DEVELOPMENT REVIEW COMMITTEE (DRC) COMMENT REPORT

PROJECT NAME: Tarpon Landings

CASE NUMBER: R19050

REQUEST: Site Plan Level III Review: Waterway Use, Conditional Use for Mixed-Use Development consisting of 248 Multifamily Residential Units, 3,650 Square Feet Restaurant Use, and 8,358 Square Feet Retail Use

Existing Stormwater Asset Map possibly affected by the Proposed Development

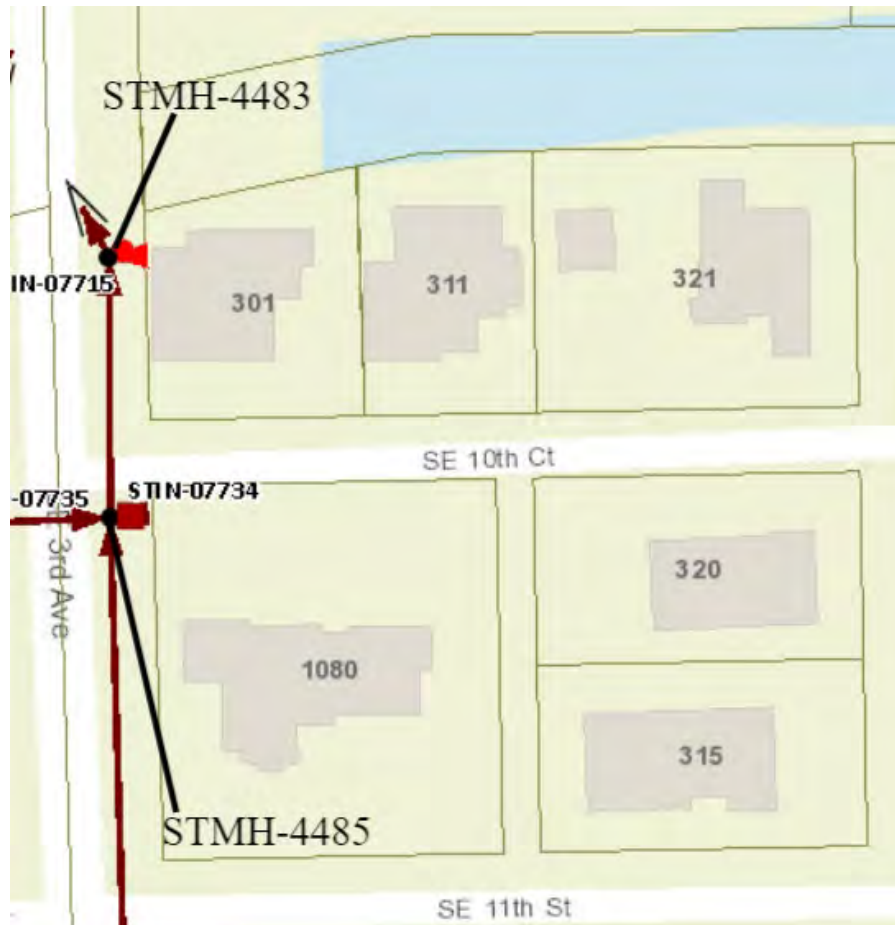
32. Conceptual Paving, Grading, and Drainage Plan:
 - a. Provide sufficient existing and proposed grades and information on conceptual Paving, Grading, and Drainage Plan and details to demonstrate how stormwater runoff will remain onsite (include typical cross-sections along all property lines as appropriate, typical lot grading for the proposed single family homes within the development, and depict how the new stormwater system will connect to the existing on-site drainage system), and how the proposed project improvements (i.e. on-street parking, sidewalks, etc.) will not adversely impact the adjacent Right-of-Way, properties and waterways. Show location of building roof drains, and their proposed connection(s) to the on-site drainage system. Label existing City storm manholes/inlets using the labels provided in the figure at the end of these notes.
